Access Compliance Report

Public Rights-of-Way

(Curb Ramps)

Intersection ID: 11763	Main Street: CARLYLE_DR	Cross Street: THORNTON_RD	Location: NW
ADA ID: 99B9ED416CBE	Ramp Type: Perp	Initial Pass/Fail: Pass	Overall Compliance: No
		Severity Score: 0

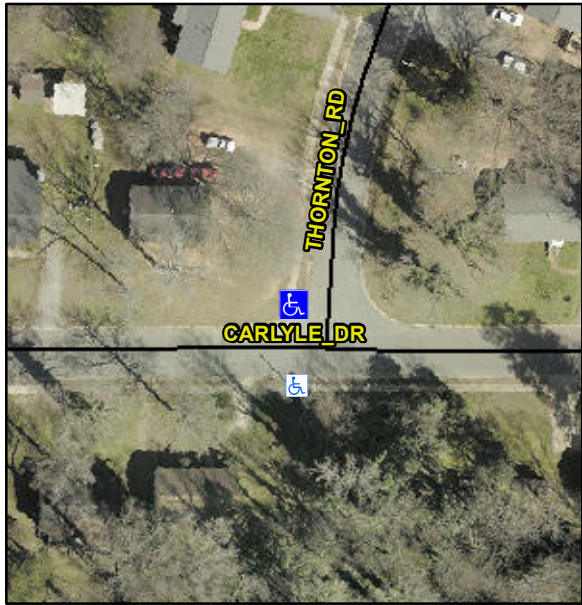
Codes/Mitigation Info/Possible Solution			Field Measurements/Component Compliance					
	Possible Solutions:		Compliance	Description	Data	Compliance	Description	Data
	Remove & Replace Entire Ramp.		N/A	Ramp Length (in)	49.0	Yes	Ramp Slope (%)	5.9
			Yes	Ramp Width (in)	48.0	Yes	Ramp XSlope (%)	1.2
			N/A	Flare Type LT	Sloped	N/A	Flare Type RT	N/A
			N/A	Flare Slope LT (%)	4.4	Yes	Flare Slope RT (%)	8.8
			N/A	Flare Traversable LT?	No	N/A	Flare Traversable RT?	Yes
			Yes	Landing Length (in)	57.0	Yes	DWS Provided?	Yes
			Yes	Landing Width (in)	48.0	Yes	DWS Contrast?	Yes
			No	Landing Slope (%)	2.5	Yes	DWS Length (in)	24.0
			Yes	Landing X Slope (%)	2.0	Yes	DWS Full Width?	Yes
Surveyor Notes:	N/A		N/A	Landing Curb? (Y/N)	No	Yes	DWS Offset (in)	0.0
			N/A	Shared Landing?	No			
			Yes	Gutter Ponding?	No	Yes	Gutter Slope (%)	1.1
			Yes	Gutter Lip Ht (in)	0.0	Yes	Gutter X Slope (%)	1.1
			N/A	Painted X Walk1?	No	N/A	Painted X Walk2?	N/A

X Walk 1 Direction	To S		X Walk 2 Direction	N/A
			N/A	X Walk 1 Width (in)	N/A	N/A	X Walk 2 Width (in)	N/A
				X Walk 1 Slope (%)	0.4		X Walk 2 Slope (%)	N/A
				X Walk 1 X Slope (%)	0.8		X Walk 2 X Slope (%)	N/A
			N/A	Ramp inside XWalk1?	N/A	N/A	Ramp inside XWalk2?	N/A
PROW/ADA:	Not Found, R304.2.2-Perp, R304.3.2-Para			Road Slope (%)	N/A	N/A	Clear Space?	Yes
				Road X Slope (%)	N/A	N/A	Clear Space to XWalk (in)	N/A
			Yes	Any Obstructions?	No	Yes	Storm Grate/Utility Hazard?	No
				Obstruction Type			Storm Grate/Utility Type	
						N/A		N/A
						Yes	Surface Condition? (G/P)	Good
Street 1 Name		CARLYLE DR						
Stop Condition-Street 2		None						
Street 2 Name		N/A						
Stop Condition-Street 1		N/A						
Total Cost:		\$ 1850.00
